MIL-N-60189(MU)
AMENDMENT 5
15 December 1969
SUPERSEDING
AMENDMENT 4
12 July 1968

MILITARY SPECIFICATION

NETWORK D CIRCUIT BOARD: 8623286

This amendment forms a part of Military Specification MIL-N-60189(MU), dated 23 February 1965.

FIGURE 2

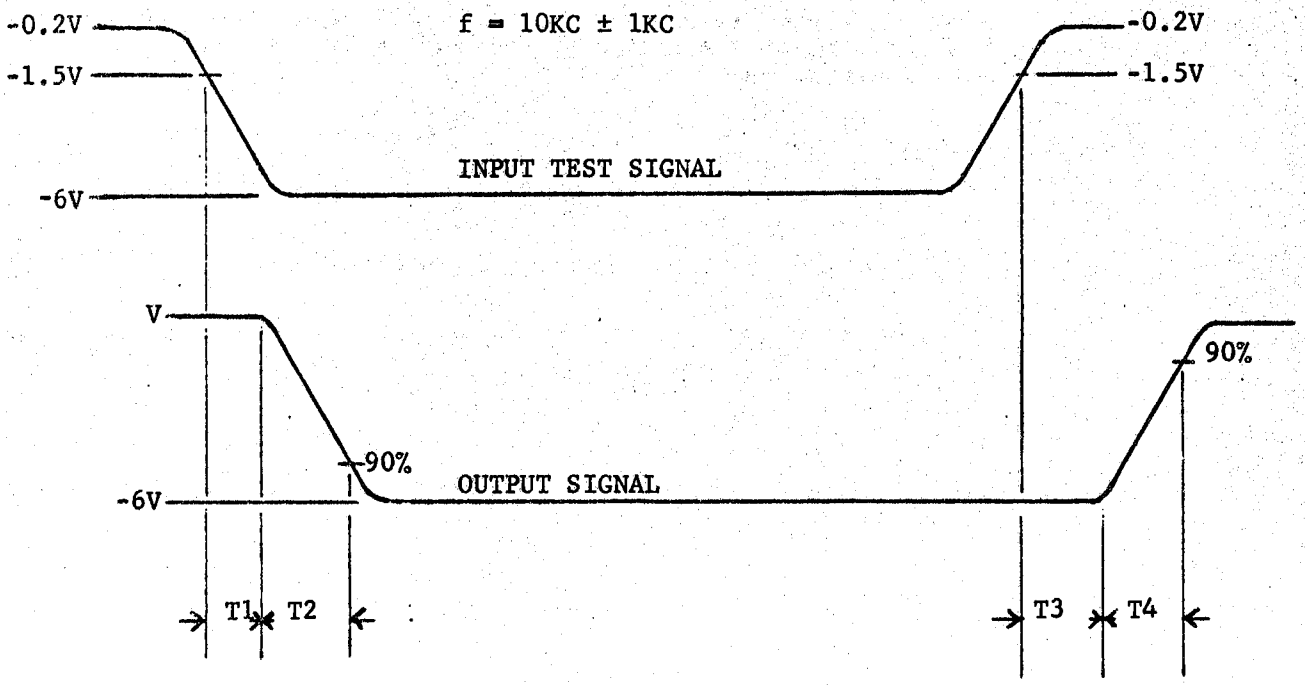
Figure 2: Delete and substitute new Figure 2 shown on Page 3 of this amendment.

Circuit	Output Volts (v)				
DUR. DLR.	+3 ± 0.12	T1 + T2 < 400 Nano. Sec.		T3 + T4	400 Nano. Sec.
REGULAR	-0.15 ± 0.15	T1 + T2 < 400 Nano. Sec.		T3 + T4	400 Nano. Sec.
		T1	T2	T3	T4
CLOCK	+6 ± 1.0	<3μ sec.	<1μsec.	<3μsec.	< 500 nano sec.
CLOCK INHIBIT	+3 ± 0.12	<5μ sec.	<1.5μsec.	<9μsec.	< 1.5μsec.

Delay time comparison of input and output waveforms. The delay time (T_1 and T_2) from the time the square wave applied to the input gate reaches minus 1.5 volts (going towards minus 6 volts) until the output reaches 90% of its total excursion (going towards minus 6 volts) and delay time (T_3 and T_4) measured from the time the square wave applied to the input gate reaches minus 1.5 volts (going towards zero volts) until the output reaches 90% of its total excursion (going towards the false state plus 3 volts) shall be as indicated in the table. The delay time (T_1) is measured from the time the square wave is applied to the input gate reaches minus 1.5V (going toward -6V) until output just starts descending and the delay time T_3 is measured from the time the square wave applied reaches -1.5V (going toward zero volts) until the output just starts rising. For extreme temperatures add 5% to the limits of $T_1 + T_2$ and $T_3 + T_4$.
